## newschannel UPDATE

RE: **Recall Campaign**– Head Lamp and Front Turn Signal Grills, Model 463, Model Years 2002 - 2010

## Remove Directional Grill and Headlamp Grill

Figure 5

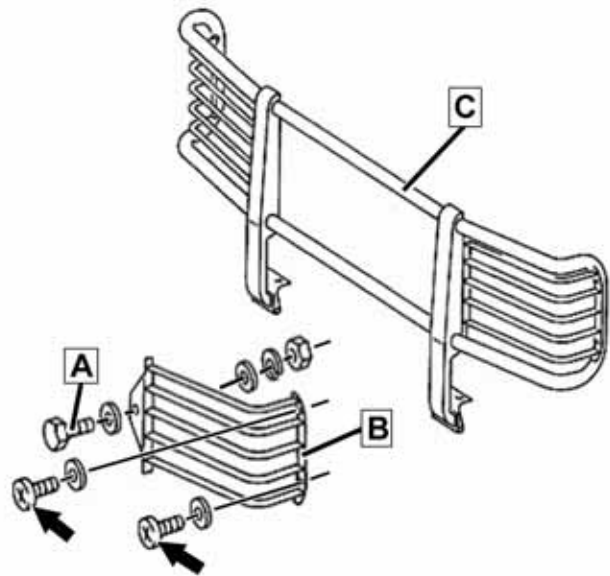
1. Remove bolt (A, Figure 5) and two screws (arrows) then remove headlamp grill (B) from front brush guard (C). Repeat this step on opposite side.

Return headlamp grills to the QEC.
